County of Loudoun
Department of Planning
MEMORANDUM

SUBJECT: SPEX 2009-0004, SPEX 2009-0015 & CMPT 2009-0003
Scott Jenkins Memorial Park, 2nd Submission

SUBJECT: SPEX 2009-0004, SPEX 2009-0015 & CMPT 2009-0003
Scott Jenkins Memorial Park

Site Concept Plan

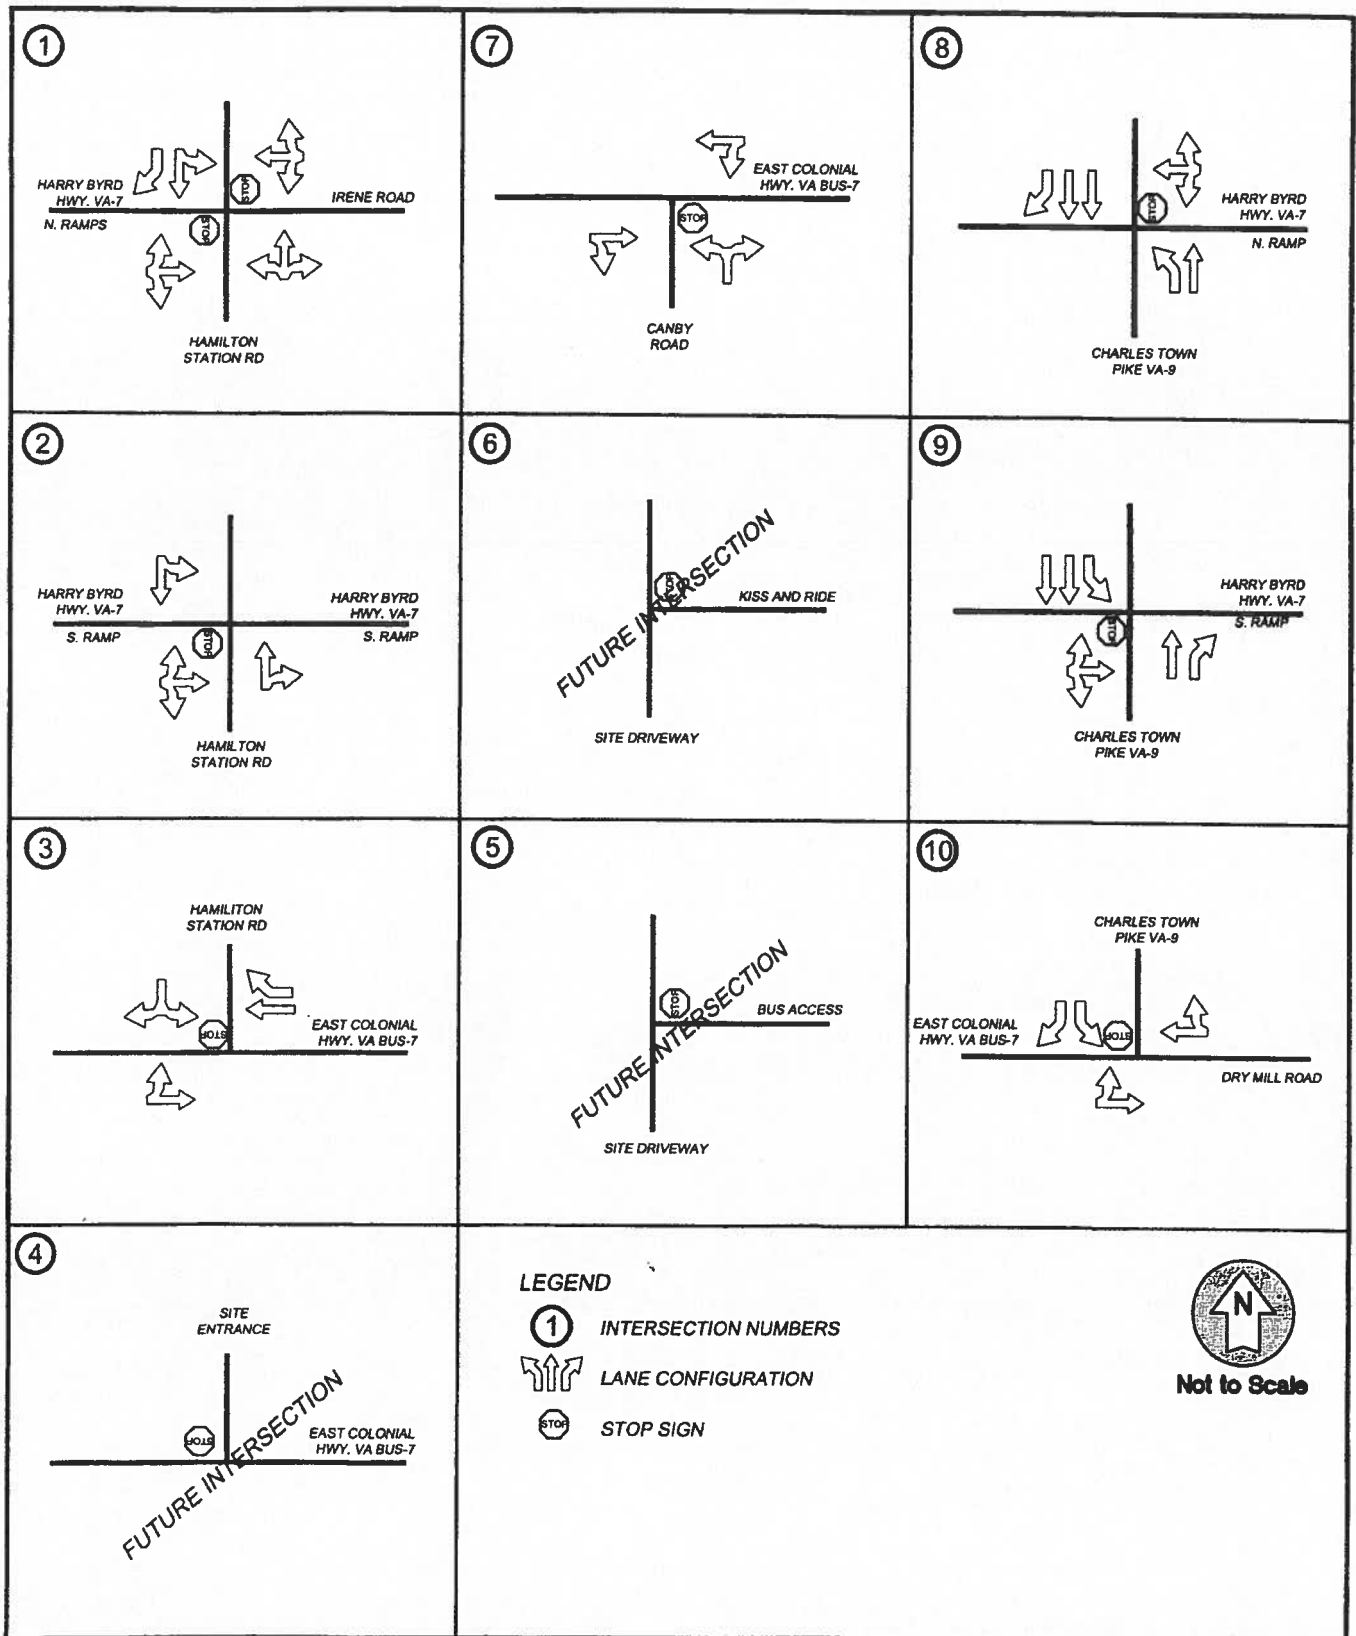
3. Initial Staff Comment (1st Referral): Consistent with the traffic study's 2010 recommendation, the eastbound left-turn lane into the main site entrance and the westbound right-turn lane into the bus access lane and main site entrance should be installed prior to the opening of Phase 1 of this project. In addition, the plat should be clarified to clearly indicate the length of each turn lane proposed.

4. Initial Staff Comment (1st Referral): It does not appear that the right-turn lane is long enough to allow for sufficient deceleration of buses accessing the site. The right-turn lane should begin at an appropriate point prior to the bus entrance.

Applicant's Response (August 11, 2009): The plat has been updated to include the turn lane lengths (taper + storage).

Applicant's Response (August 11, 2009): The right turn length into the bus area has a storage length of 410 feet to the return and 190 foot taper. The VDOT Road Design Manual requirements show a 200 foot turn lane with 200 foot taper. The increase in storage length, as measured from the bus entrance curb return, reflects adequate AASHTO deceleration area for the buses at a 55 MPH speed, with the inclusion of turn lane and taper area. The proposed design should satisfy VDOT requirements.
